工程指示 / 要求簡箋(E.I.)

工程指示編號：EI / 1515 / 20 修改版次：

工程名稱：亞皆老街中電

工程項目：Showflat 後加工程

Revised Details for
noise screen cover

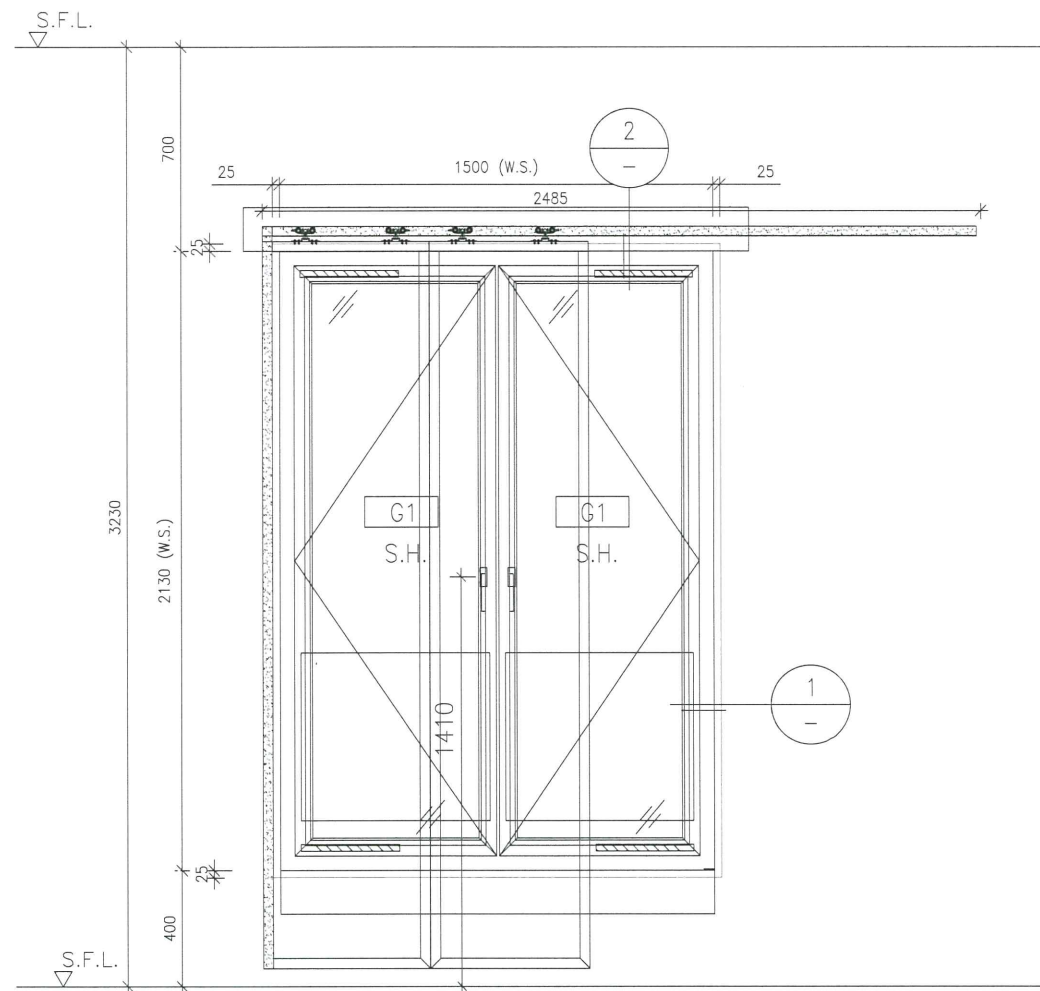
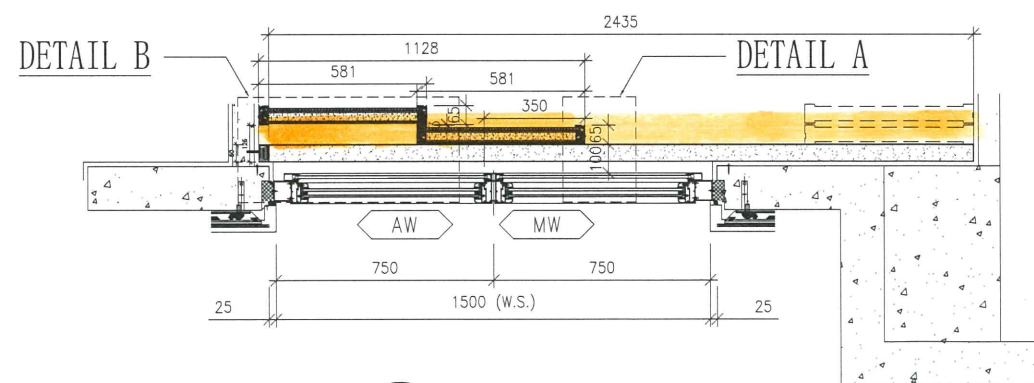
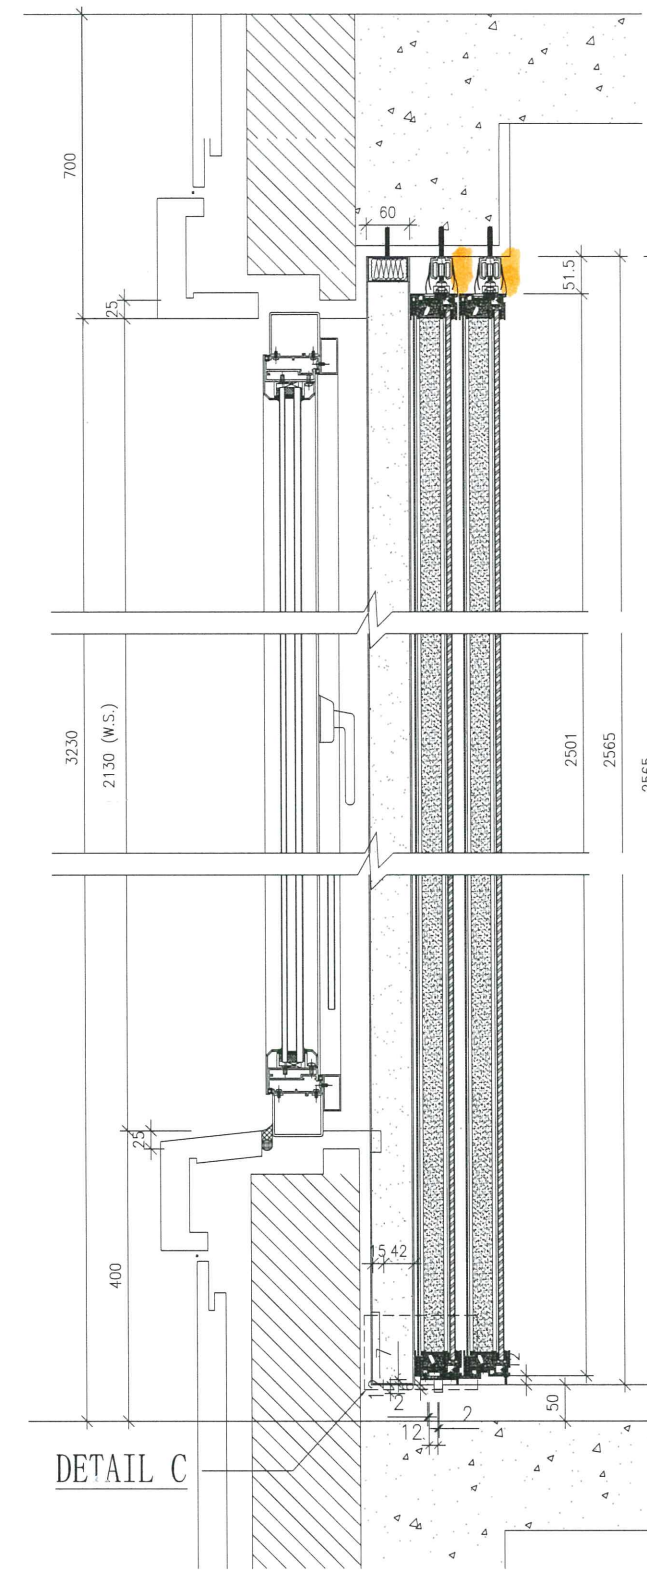
1. 隔音板路軌 加鋁板

鉛板長度 = 2445mm (覆尺數)

加鉛板位置

Rev 修訂	Date 日期	Note 备注	Rev 修訂	Date 日期	Note 备注	Project 工程名稱	Title 項目	Drawing No. 圖號
A						CLP	W1101-P W107-Uuit A B.R.2	004
B					ARCHITECTURAL ACOUSTICS		Job No. 工程編號 -	Date 日期 2019-10-16
C					建築聲學		Drawn 繪圖 QING	Scale 比例 A3
D							Check 校核 Austin	Rev 修訂 A

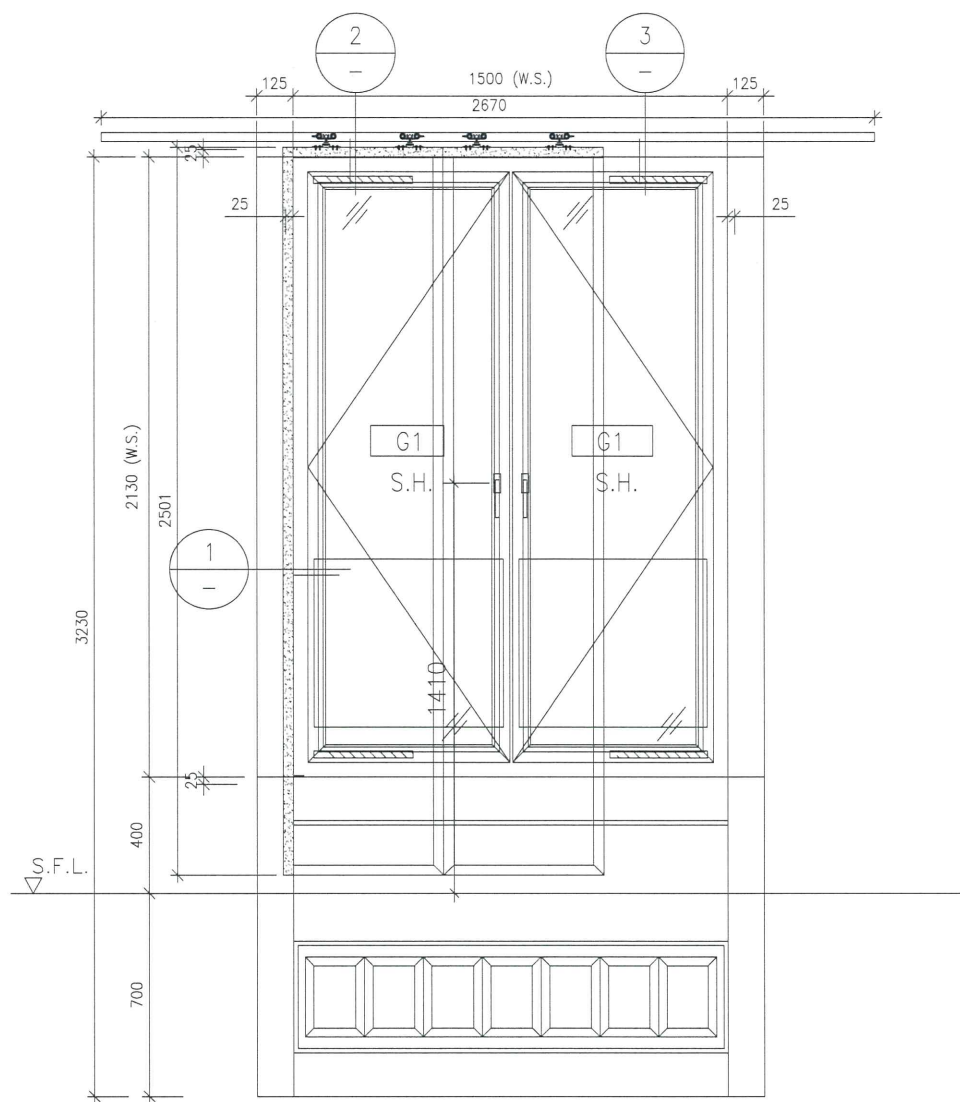
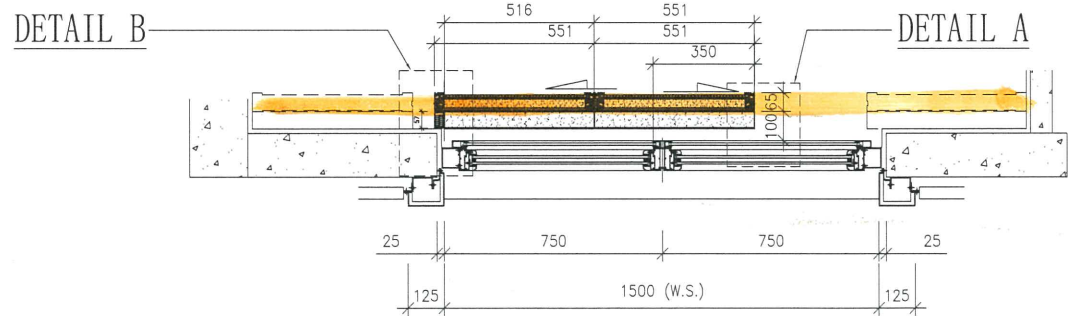
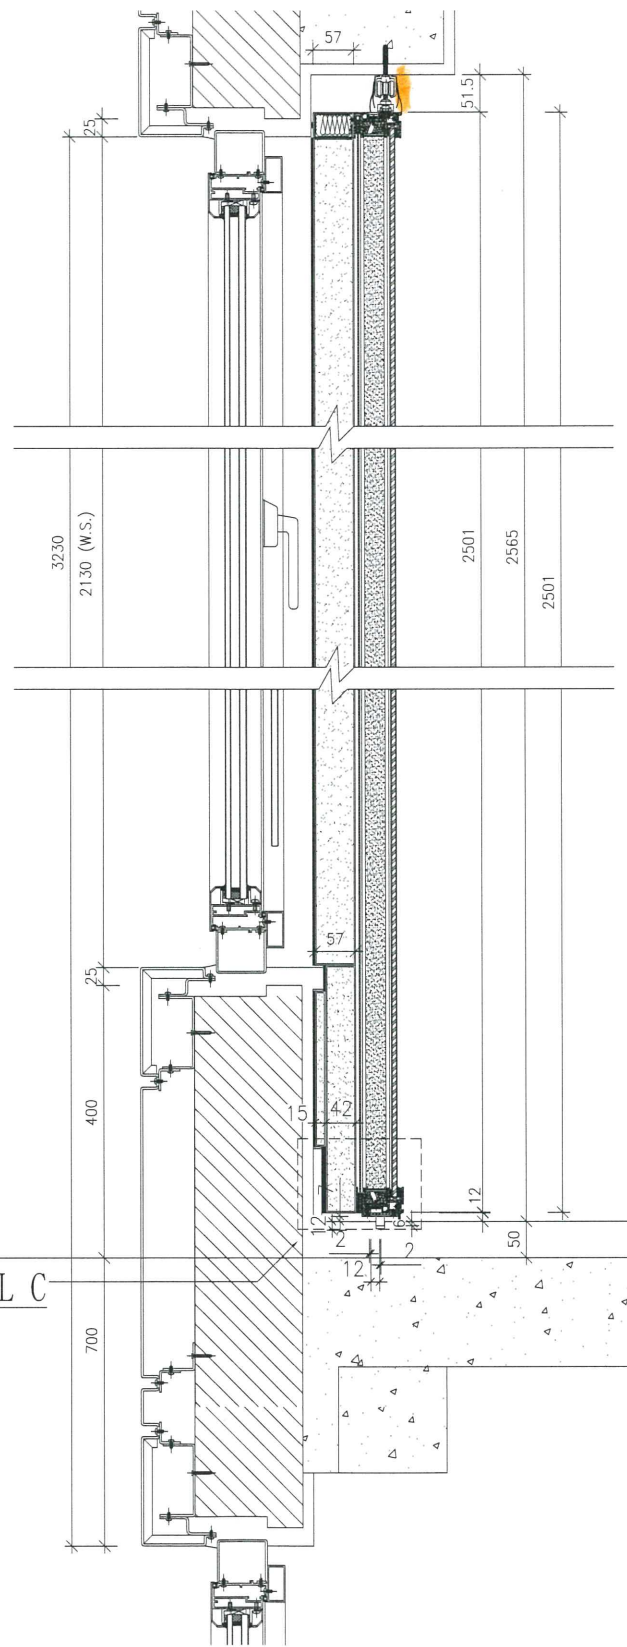
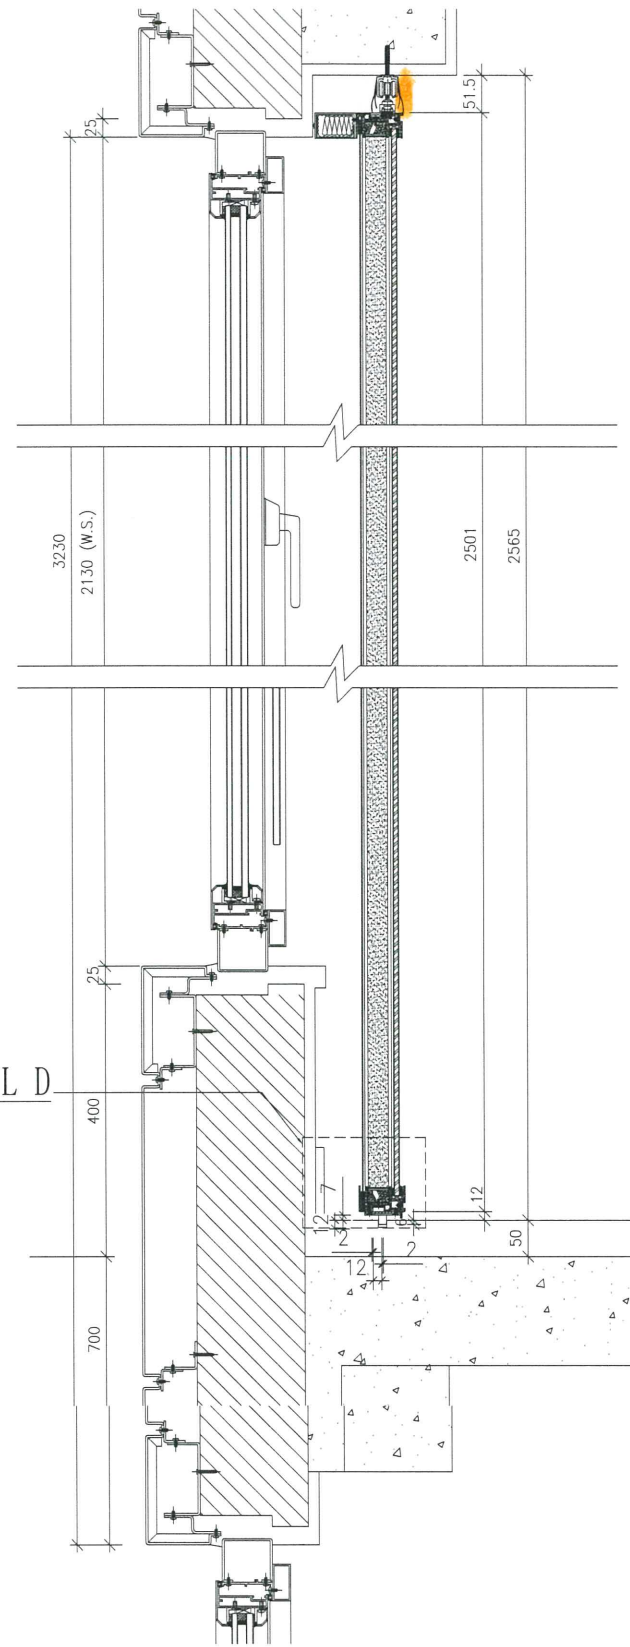
鉛板長度 = 2660mm
(覆尺數)

加鉛板位置

Rev 修订	Date 日期	Note 备注	Rev 修订	Date 日期	Note 备注	Project 工程名称	Title 项目	Drawing No. 图号
A						CLP	W1106-P W101-Uuit A MASTER ENSUITE	006
B					ARCHITECTURAL ACOUSTICS		Job No. 工程编号 -	Date 日期 2019-10-16
C					建筑声学		Drawn 绘图 QING	Scale 比例 A3
D							Check 校核 Austin	Rev 修订 A

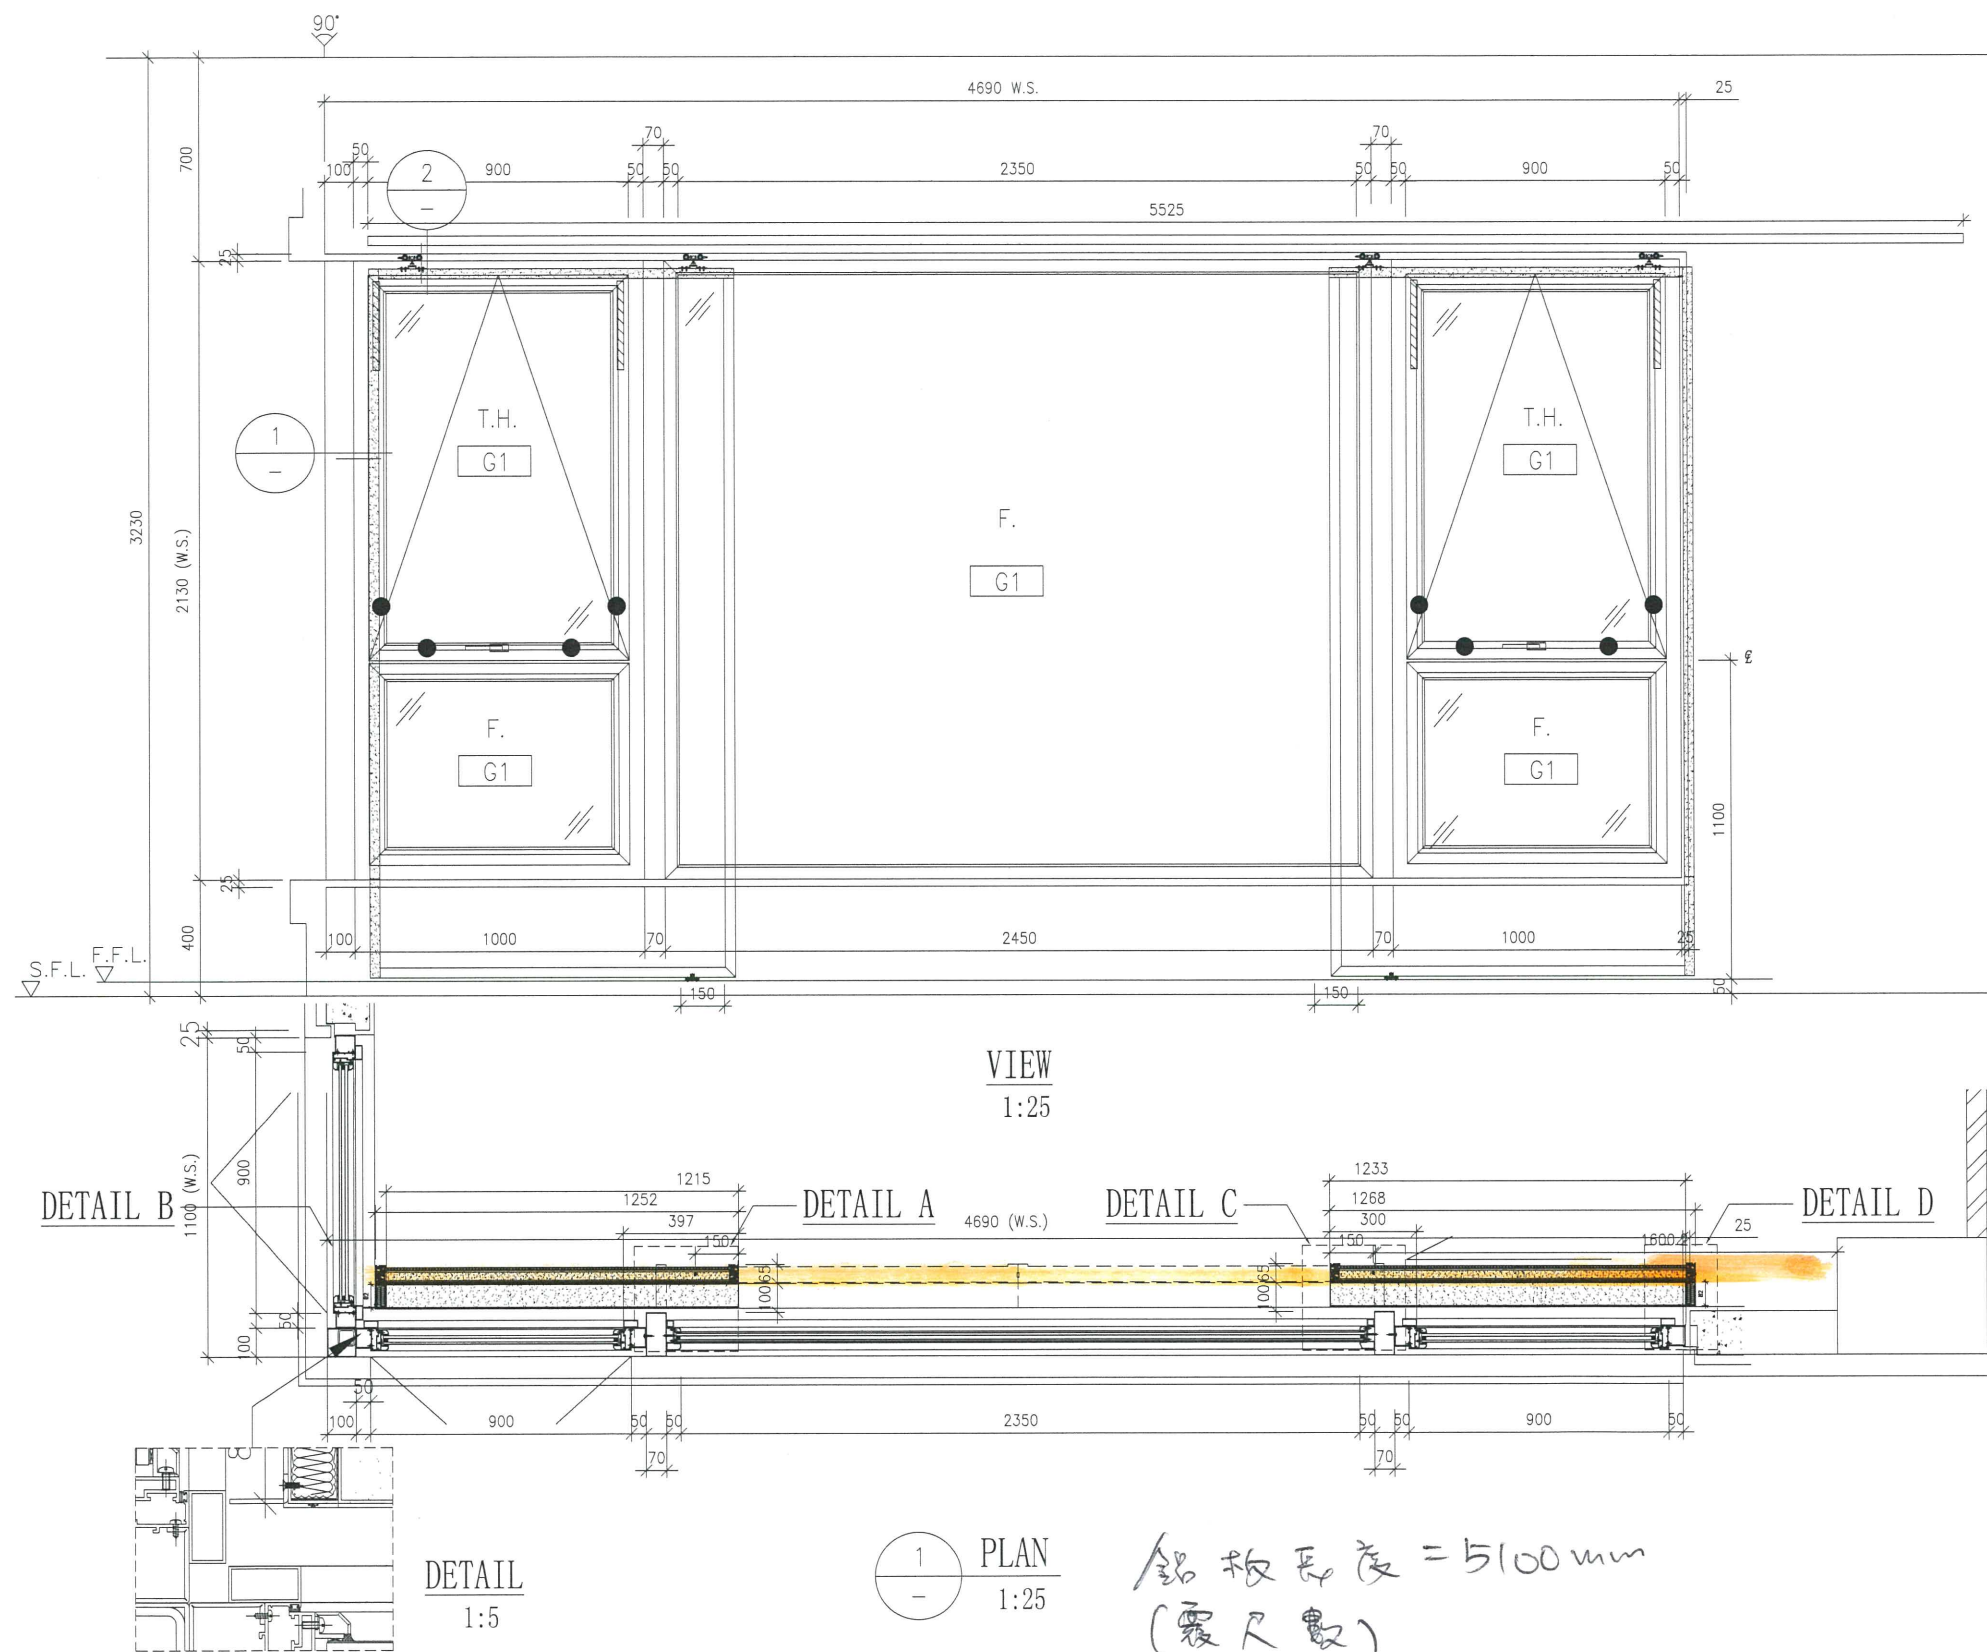
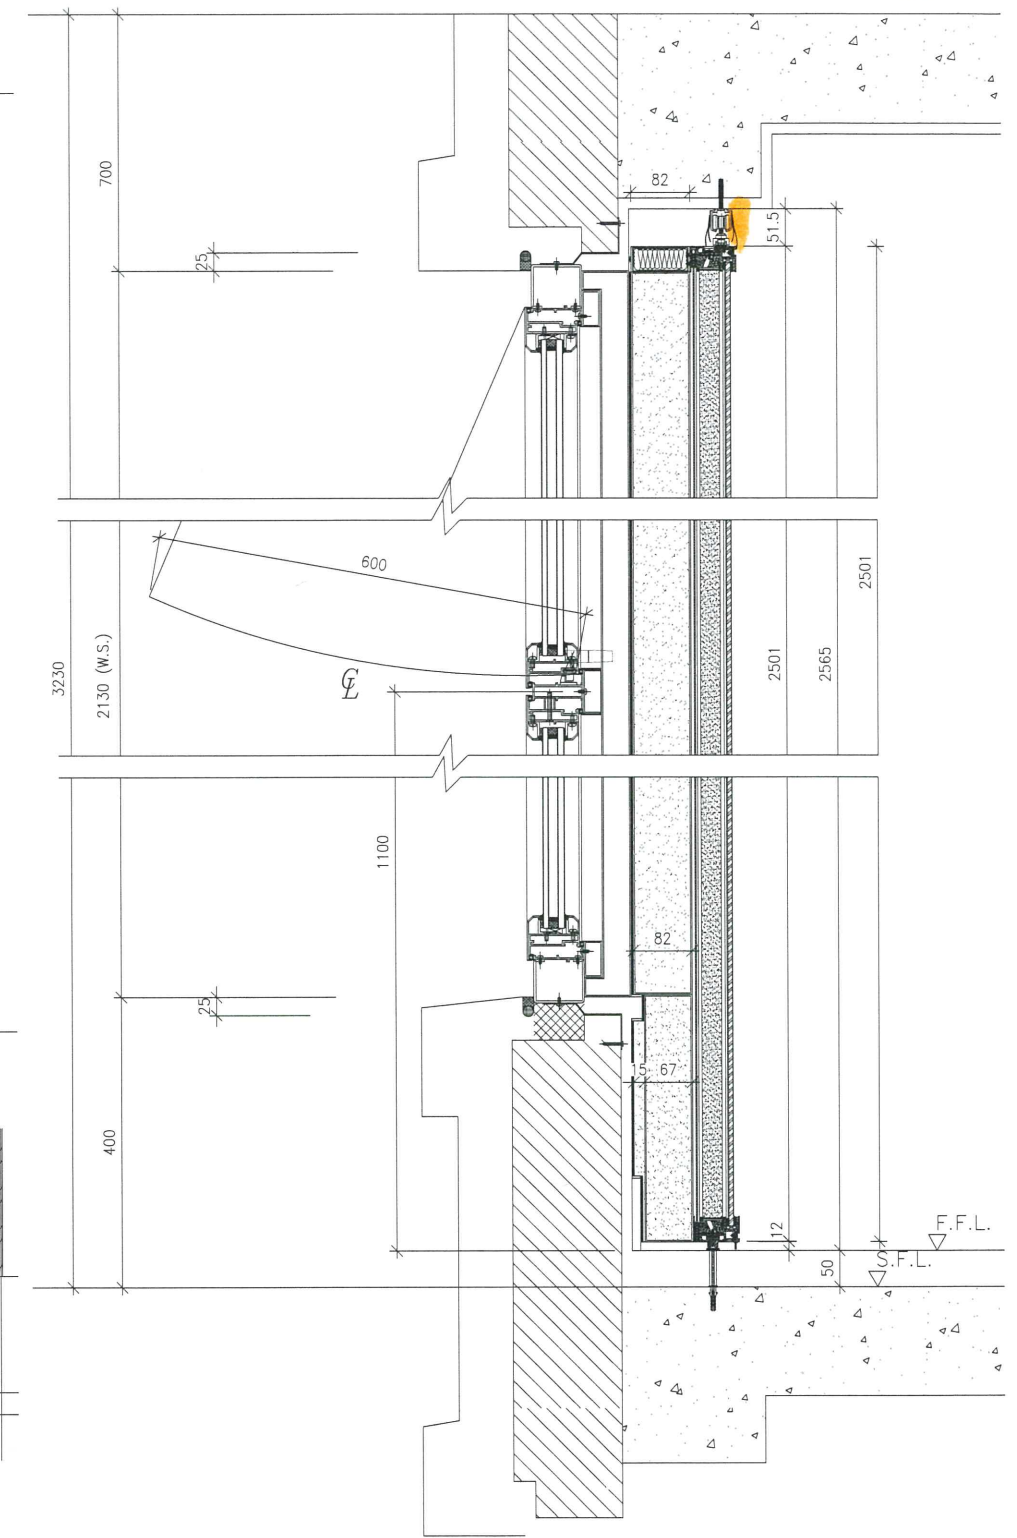
鋁板長度 = 5100mm
(覆尺數)

加鋁板位置
